Williamson County Sheriff's Office Training Center

SI 005 Conections at Windows

PROJECT: Williamson County Sheriff's Office Training Center SUPPLEMENTAL INSTRUCTION

Item No. 1. Refer to the attached drawings SK-01 and SK-02 from Datum Engineers for clarifications to the comments provided in

# CONNECTION OF CANTILEVER STUDS AT WINDOW SILL TO SLAB

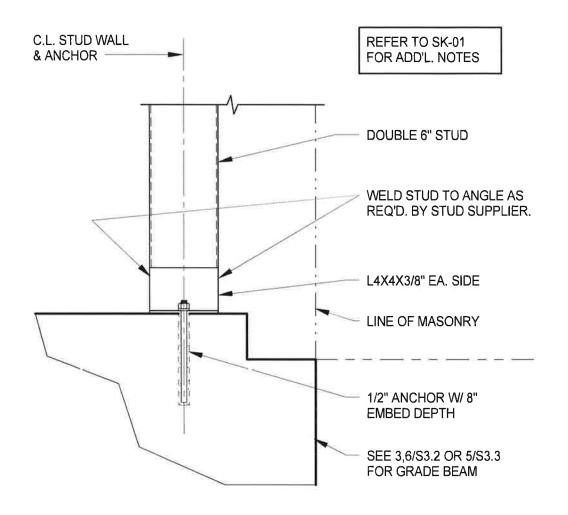
Matt, I need to get the angles and bolts in the attached SI. This happens at 70 locations so I need 140 of each. Also it shows the angle to be 6" long but I need them to be 5 3/4" so they will fit inside a 6" track.

Description: SI #05- Larger Bolts and added stud required at clips per EOR
